NATURA IMPACT STATEMENT ADDENDUM

Response to Request for Further Information

Bruree Bridge, Bruree, Co. Limerick

Our ref: ABP-322242-25
ABF Ref: 177AE Bruree Bridge

Figure 2. Otter survey area to the west of the bridge.

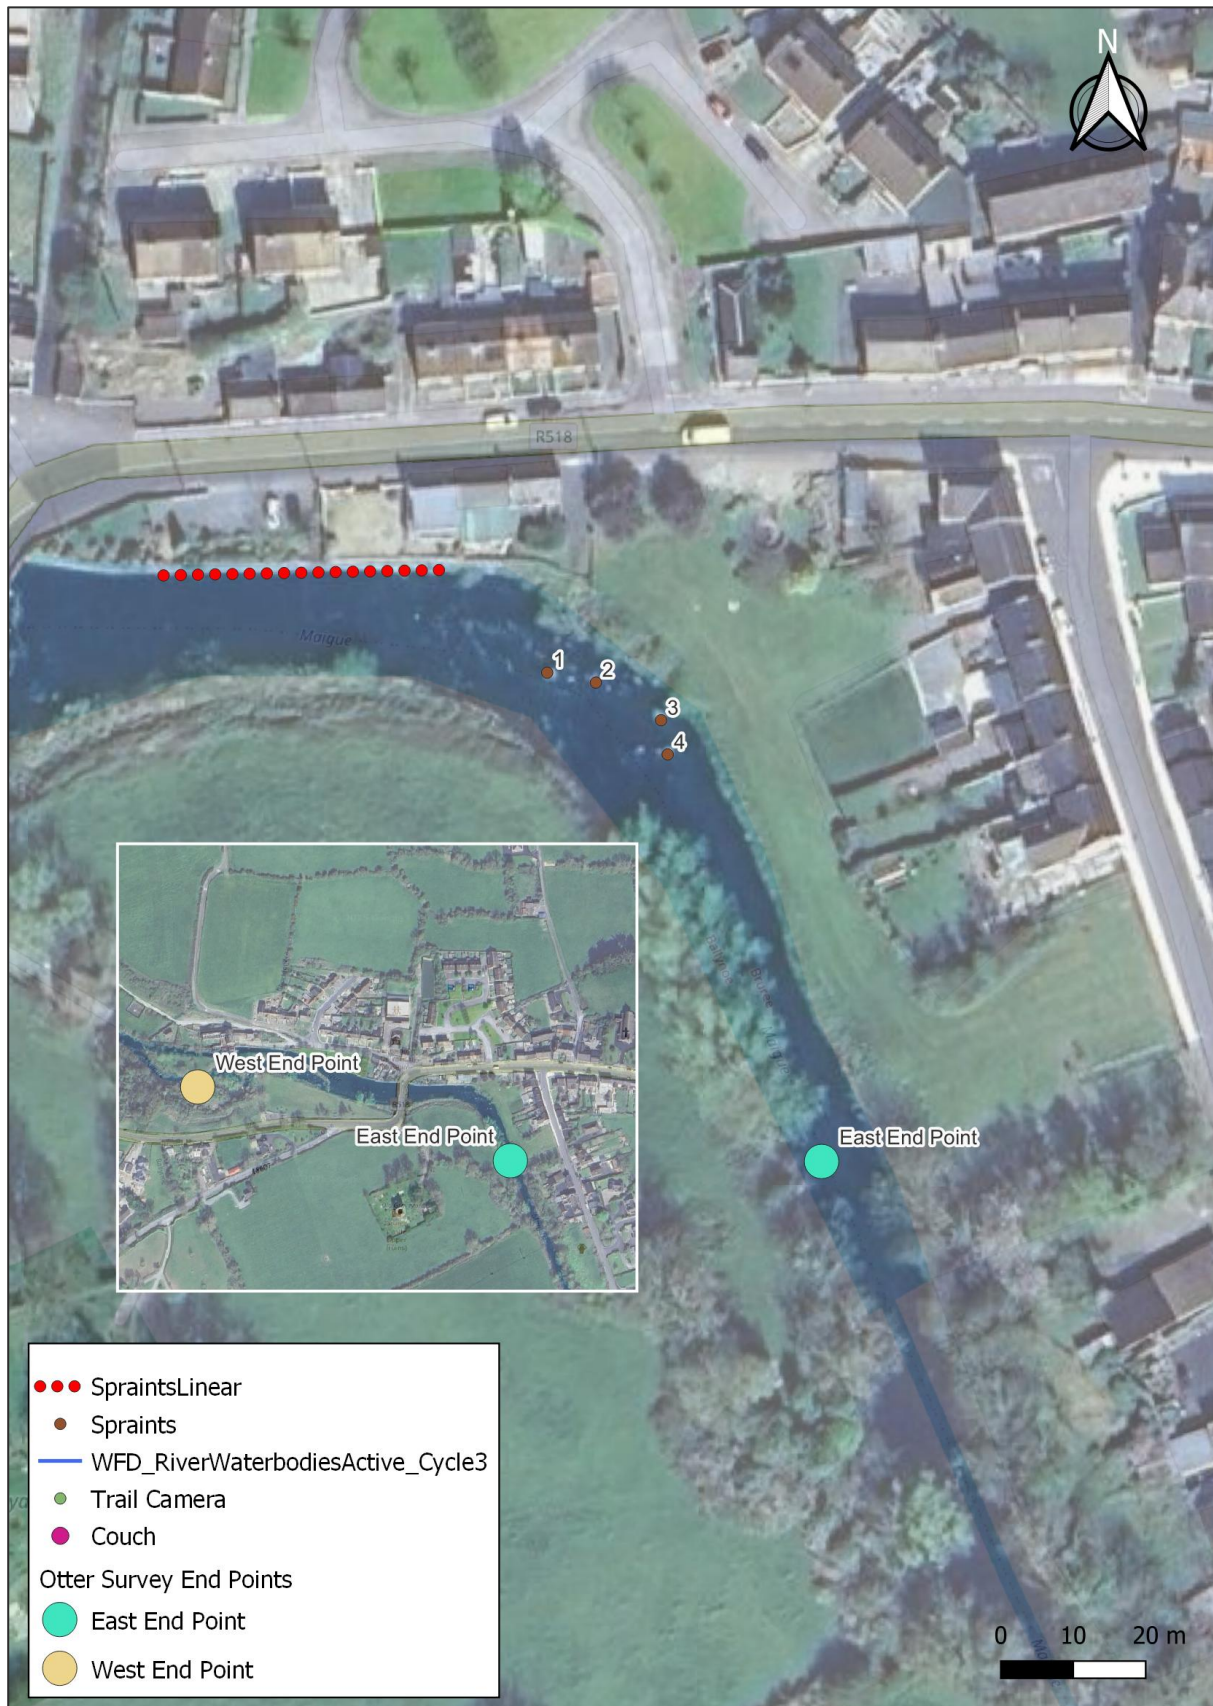
- *An updated survey of current Otter usage of the bridge area and a 100 m stretch upstream and downstream.*
- *The survey report should clearly describe area covered and level of survey effort.*
- *Mitigation must ensure that Otter passage through the semi-dry arch is not blocked, even temporarily, during works.*
- *Flexibility in dry-cell design should be incorporated (e.g. using lower sandbag heights, only partial arch blocking, or providing access ramps over sandbags).*
- *The final survey should recommend site-specific mitigation, in liaison with the works contractor*

The survey extended for 200 metres downstream and 115 metres upstream. See maps in section in 5.5.

To the east of the bridge there a number of areas where otter spraints were found. In the river channel itself, emergent rocky debris (looks as though from a previous walled bank) was clearly frequented by otters as there were four separate sprainting sites. All sites had fresh and old spraints present. The north bank is a heavily modified man-made structure. There is a slight lip which stays out of the water, except during very large floods. This lip has a lot of otter activity, with a number of fresh and old spraints present. The frequency of spraints was observed to decline as we moved closer to the bridge. No holts, couches, or slides were found on the south bank of the eastern side of the bridge. Signs of otter activity continued for 90 metres upstream of the bridge.

Downstream there were a total of 9 separate sprainting sites. Activity close to the bridge itself was minimal until the weir is reached. As the weir is old it is damaged in places. Near the southern bank at the western end of the weir, there is a chute in order to facilitate fish passage. Either side of this there was evidence of otters couching. This is an ideal location to hunt. As fish try to make their way up or down the chute they become easily predated by otters. There were spraints close by to the couching locations. Evidence of otter activity continued downstream with any prominent rocks having spraints present. Evidence of otters was found to continue for 175 metres downstream of the bridge. This area consists of a series of stepped pools and cascades which would hold up upward migrating fish and disorientate downward migrating fish; in both cases making them easier to catch for otter. As such, this is excellent otter hunting habitat, and would no doubt be a coveted reach of river territory. No holts or slides were found on the western side of the bridge.

Figure 4. Plan of works.

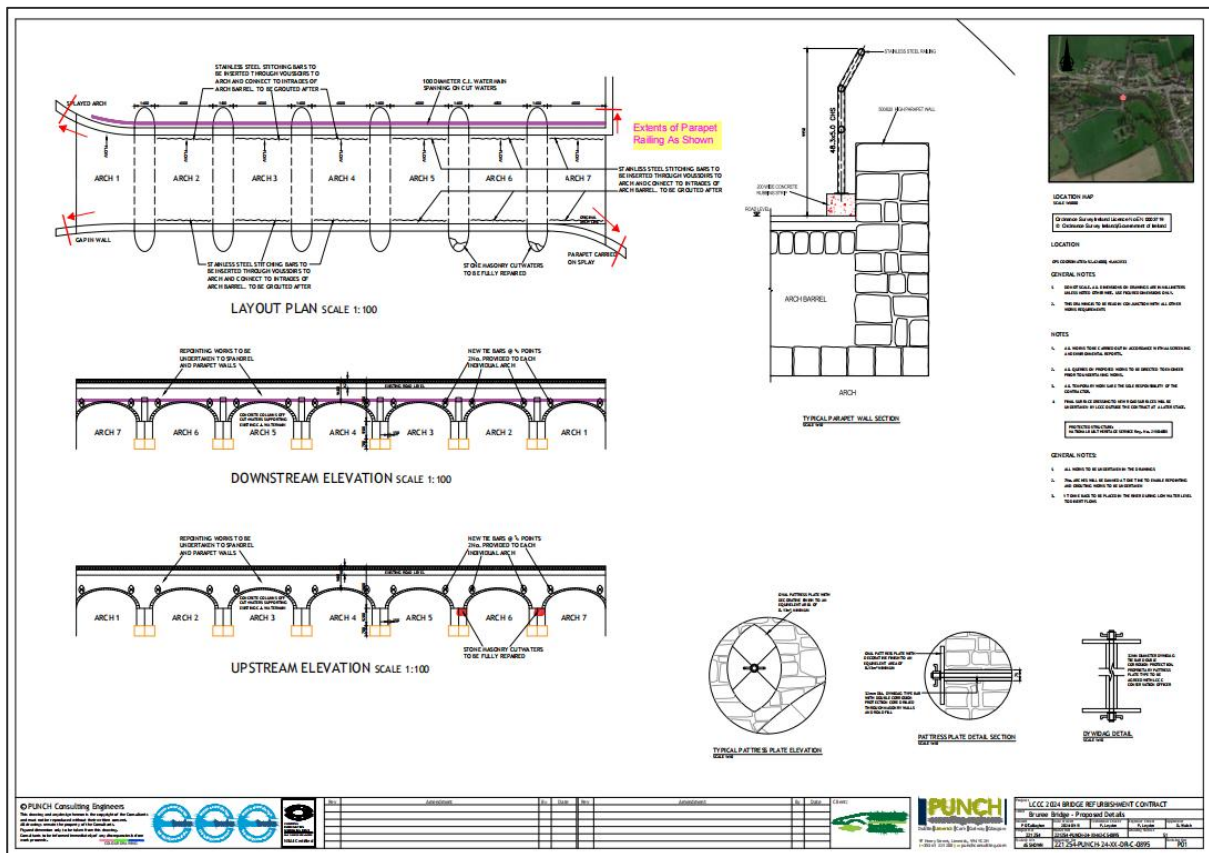
- Any water that contacts cement (curing water or runoff) must not be pumped back into the river but instead removed off-site.
- The sealed-off dry cell area should only be re-watered after cement at the waterline has fully cured.
- A detailed works schedule and method statement is required, setting out how these measures will be implemented, with ecological input and IFI consultation.
- Because mitigation (including any NPWS licence conditions for bats and otters) could change the works programme, the Board require that the final detailed methodology and ecological reports be submitted for approval before consent is granted.

The refurbishment works to Bruree Bridge are expected to take approximately 6–8 weeks in total. The sequence of activities is outlined below:

- Temporary timber decking can span onto existing concrete skirtings to provide a work platform
- Scaffolding beneath the arches will be fully sheeted with impermeable heavy-duty tarpaulin or PVC sheeting.
- The sheeting will be lipped at the edges to form a continuous tray beneath the work area.

- Runoff from the tray will be directed into sealed collection containers.
- Secondary debris netting will be installed beneath the sheeting to intercept mortar fragments or chippings.
- This system will ensure that no grout, mortar, or wash water can enter the river.
